DECISION NO. RRJ0000-OR-470-7229

for replacement of the bolts providing the reduced tightness in the connection joint of the attachment mounts with the horizontal stabilizer hinge bracket on the RRJ-95 aircraft

**Procedure for
replacement of T7.92.3100.077.000.73 hollow bolts to T7.92.3100.177.000.73 bolts**

Demounting of the hollow bolts (T7.92.3100.077.000.73) along the upper hinge fitting
of the stabilizer
Figure 1 (sheet 1 of 3)

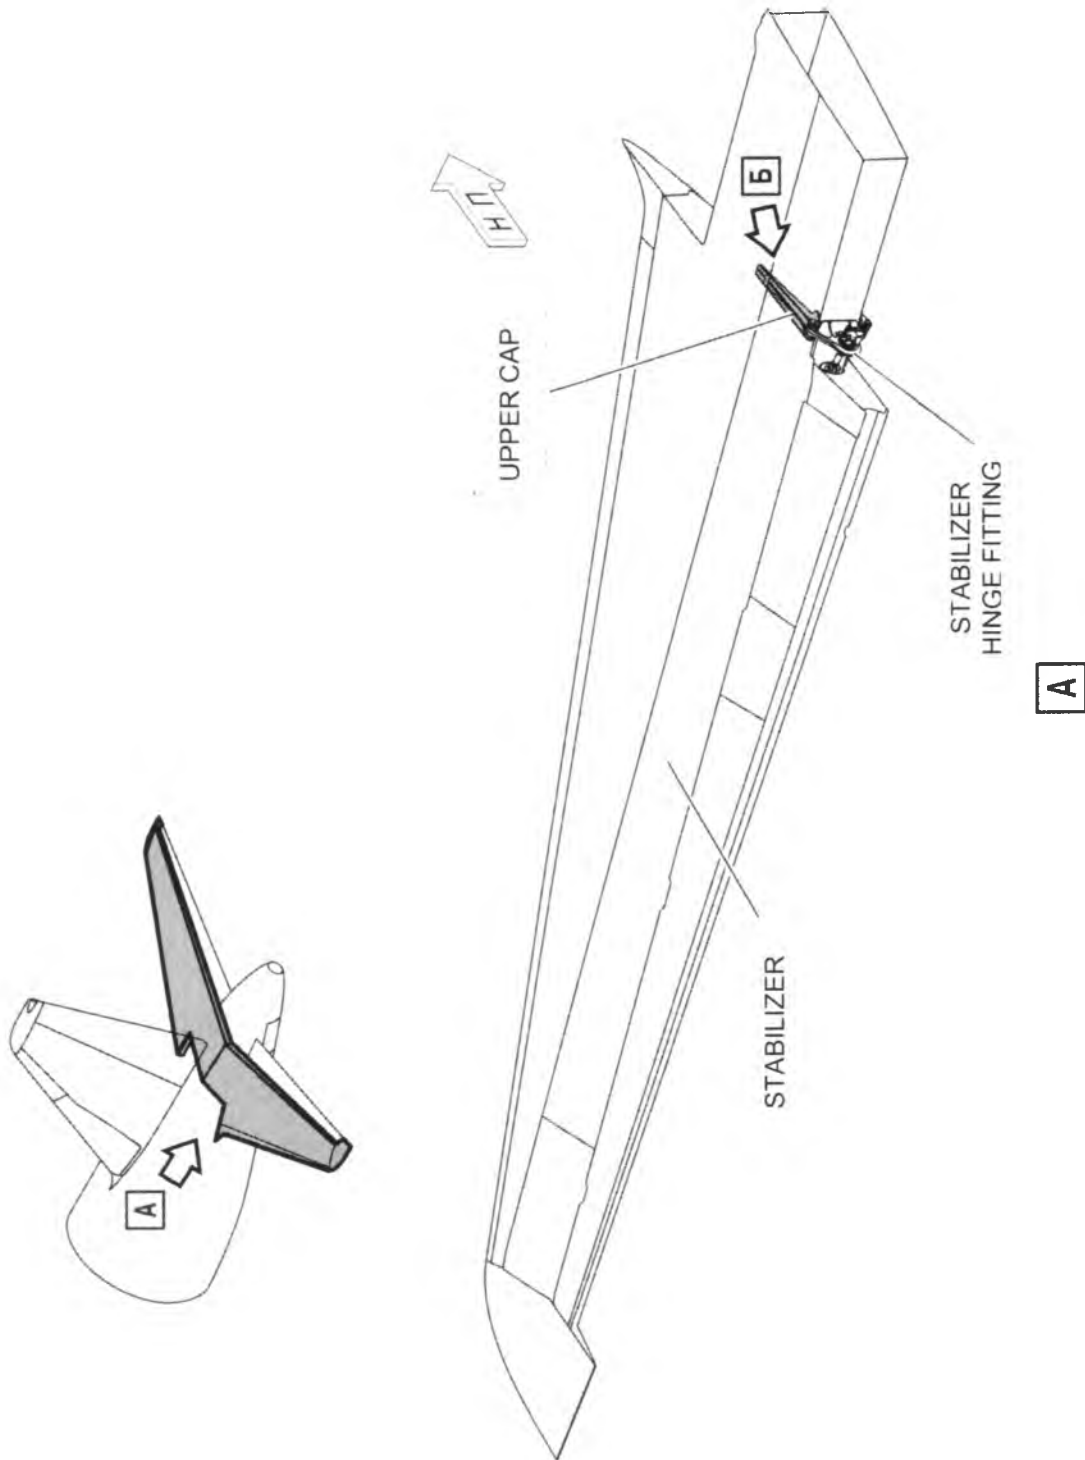
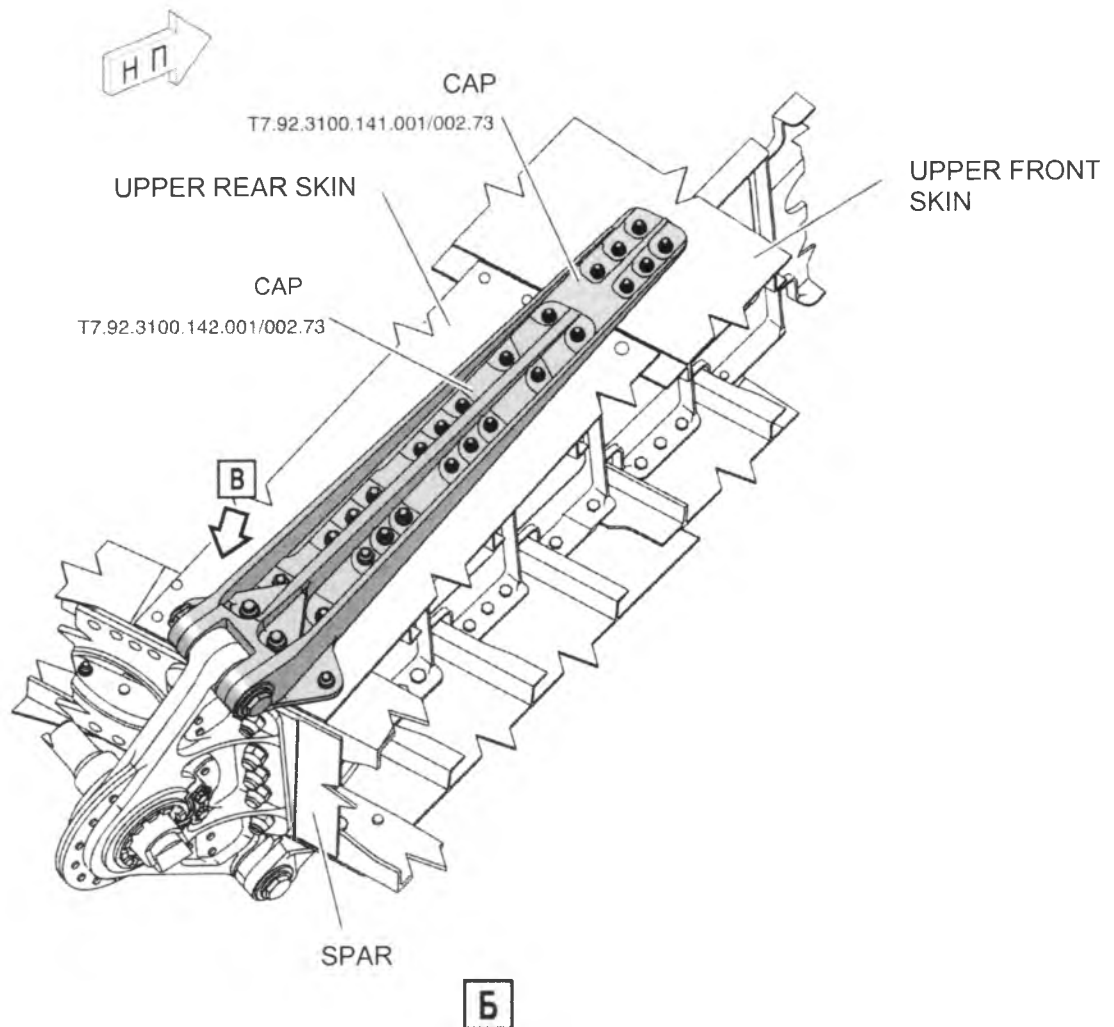
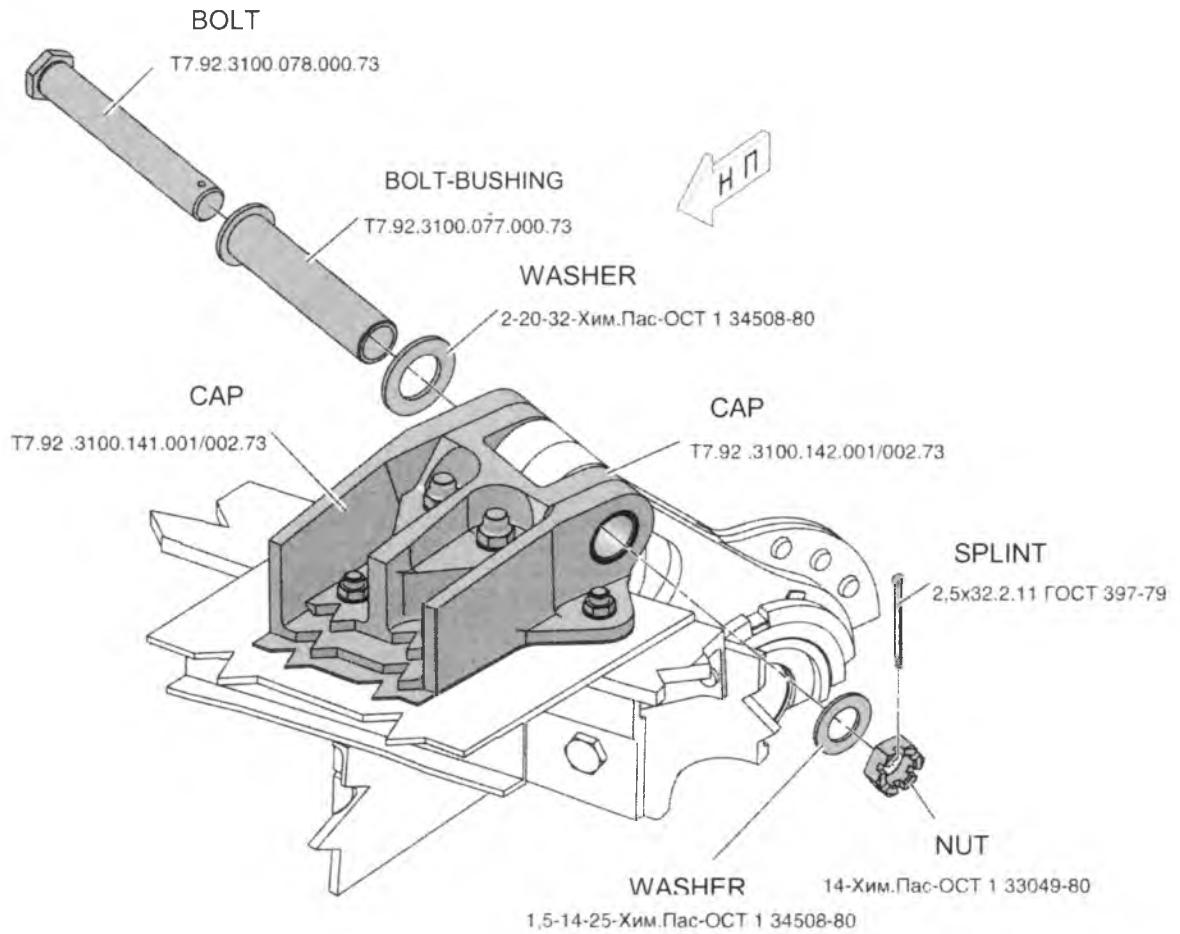
- (1) Demounting of the hollow bolt (T7.92.3100.077.000.73) along the upper hinge fitting of the stabilizer (see Fig. 1).
 - (a) Clean the surfaces of the upper cap from dirt with cleaning rags dampened with НЕФРАС-C2-80/120 solvent if necessary.
 - (б) Remove the 22,5x32.2.11 ГОСТ 397-79 splint and discard it.
 - (в) Remove the 14-Хим.Пас-ОСТ 1 33049-80 nut of the upper cap attachment to the fitting of the stabilizer. Save the nut for the further installation
 - (г) Remove 1,5-14-25-Хим.Пас-ОСТ 1 34508-80 washer and save it for the further installation.
 - (д) Remove the bolt (T7.92.3100.078.000.73) and save it for the further installation.
 - (е) Carefully remove the bolt-bushing (T7.92.3100.077.000.73) from the lugs of the upper cap. Discard the bolt-bushing.
 - (ж) Remove 2-20-32-Хим.Пас-ОСТ 1 34508-80 washer and save it for the further installation.

Installation of the hollow bolt (T7.92.3100.177.000.73) along the upper hinge fitting of the stabilizer
Figure 2 (sheet 1 of 3)

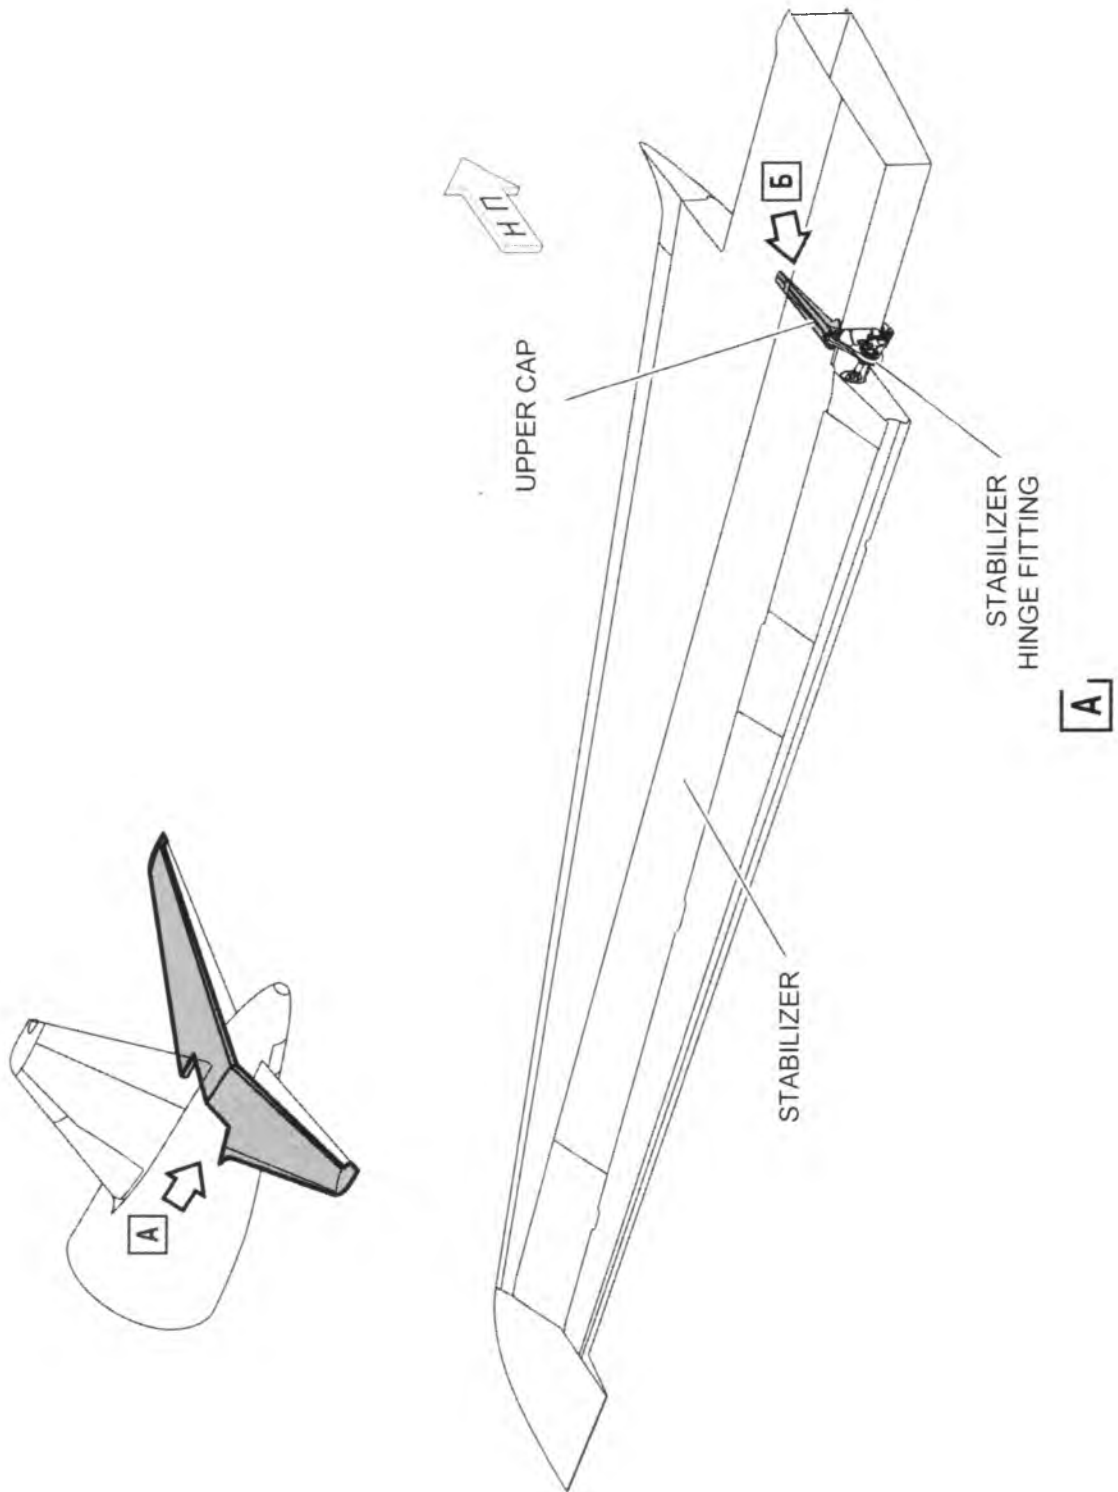
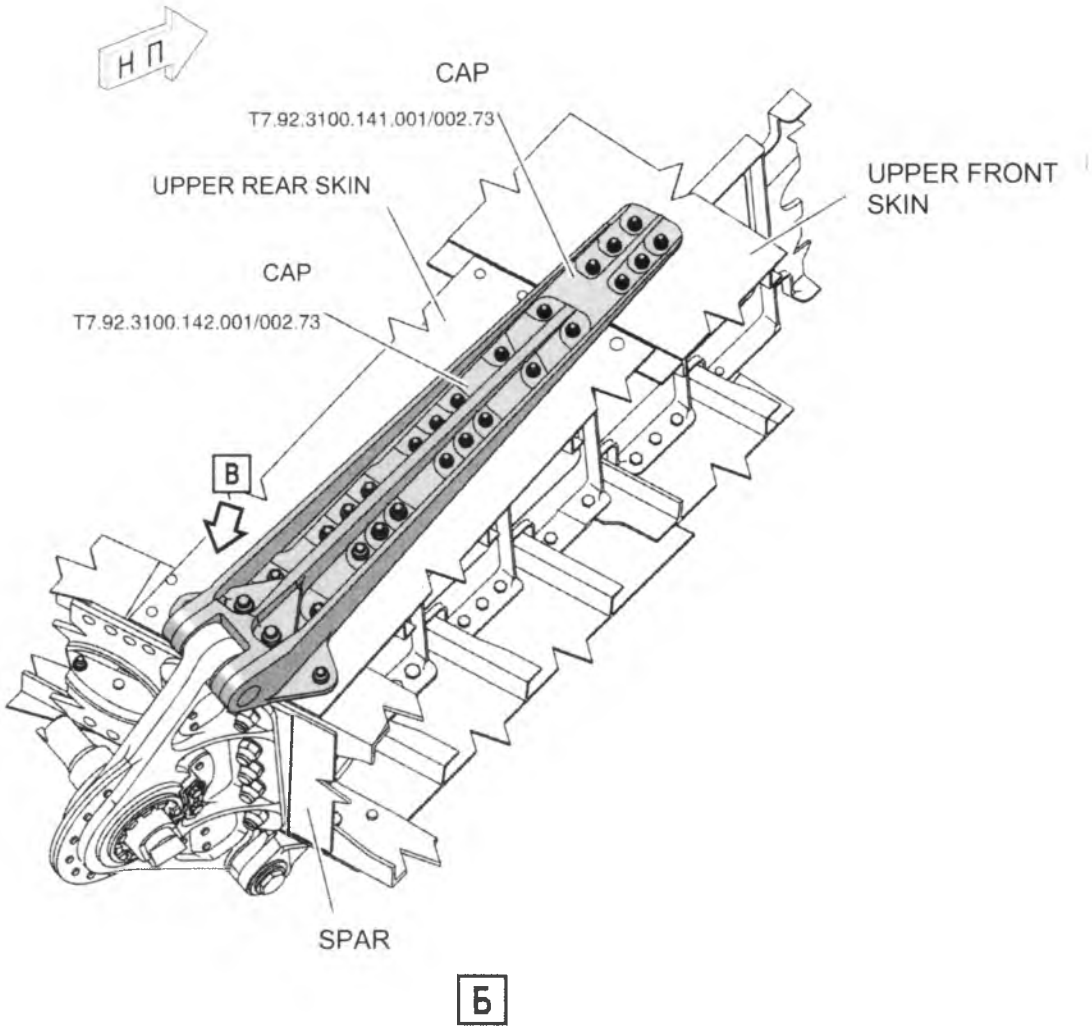
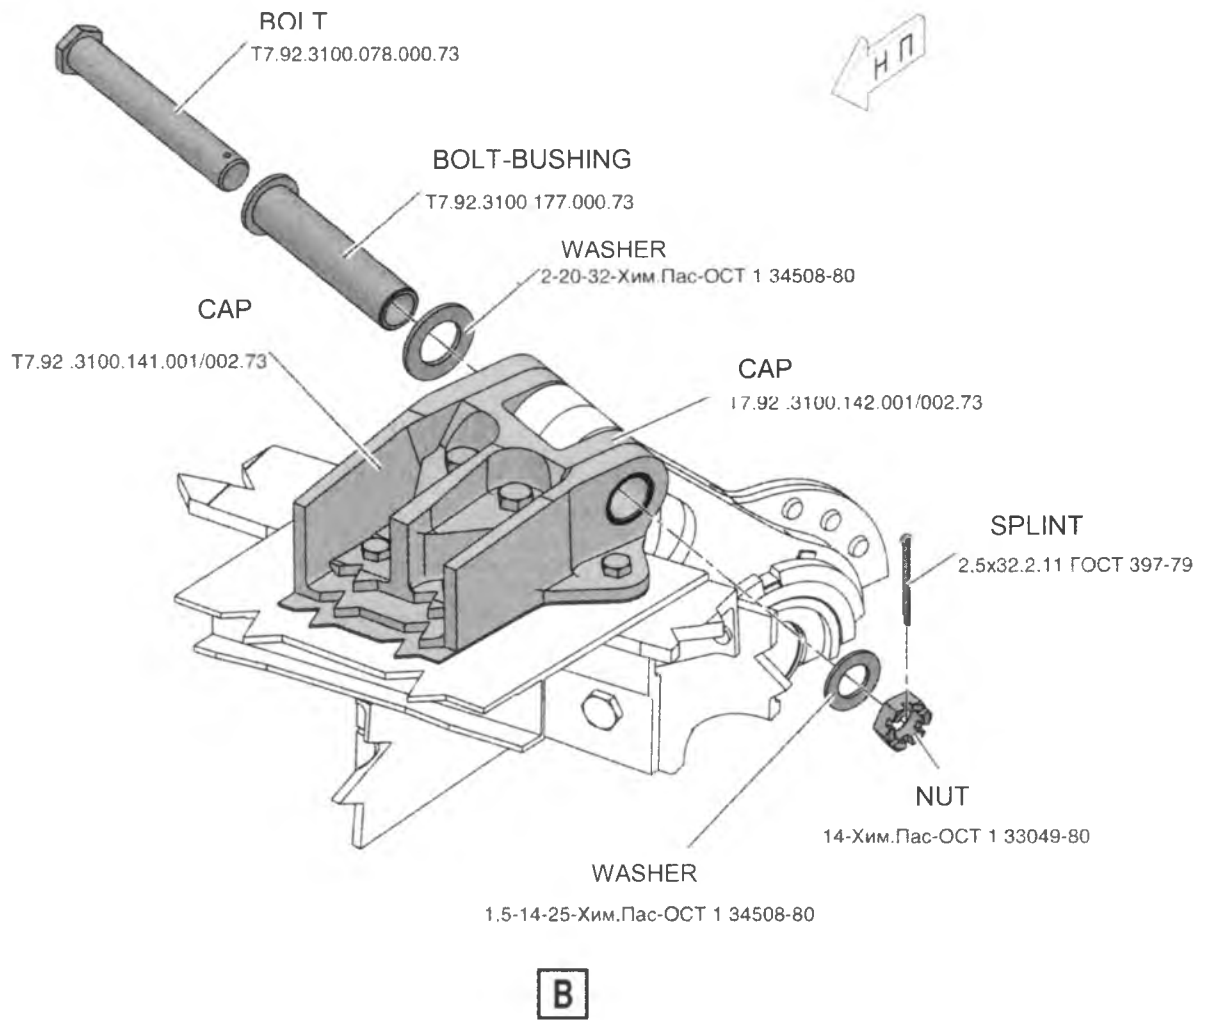
(2) Installation of the hollow bolt (T7.92.3100.177.000.73) along the upper hinge fitting of the stabilizer (see Fig. 2).

(a) Install the previously removed 2-20-32-Хим.Пас-ОСТ 1 34508-80 washer and new bolt-bushing (T7.92.3100.177.000.73) to the lug of the upper cap.

(б) Install the previously removed bolt (T7.92.3100.078.000.73).

(в) Install the previously removed 1,5-14-25-Хим.Пас-ОСТ 1 34508-80 washer.
